224 Katie Lynn Court

CONSTRUCTION PERMIT APPLICATION

2ND STORY ADDITION ABOVE GARAGE & FAMILY ROOM/PROPOSED 2 NEW BEDROOMS/
RE-LOCATION OF 1ST FLOOR FURNACE & HWY TO GARAGE/VINYL SIDING FOR WHOLE
HOUSE/NEW ROOF SHINGLES FOR ENTIRE HOUSE

Proposed 2nd Floor Addition
 Block 323.23, Lot 7
 Rev. 1
 Brick, New Jersey

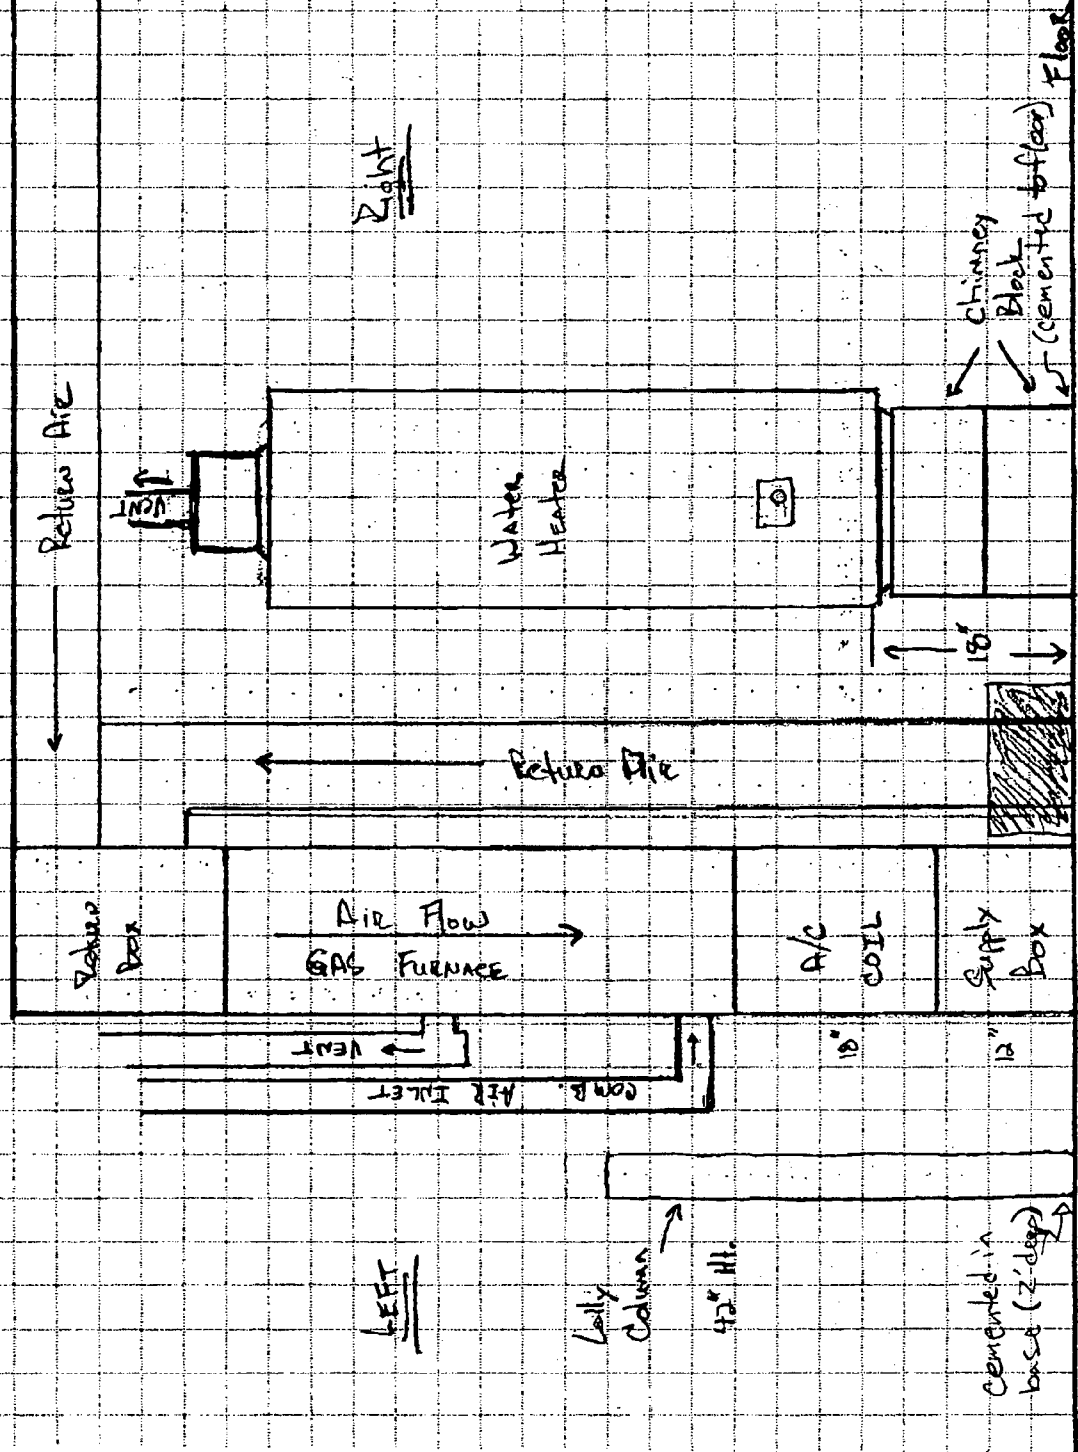
No.	DESCRIPTION	Code Section
①	FTO Requires Rated Ceiling to be supported by Rated Walls (Not shown)	
②	Relocated Utility Area shows No Details Framing, Height off Floor & impact Protection	
③	Cross Section Drawing shows Floor in Garage at same Elevation as dwelling	
④	Ridge Size Not indicated.	
⑤	Soffit & Ridge vents Not shown	
<u>HO took plans</u>		<u>called HO 12:50 spoke to wife</u>

All revisions are shown in red.
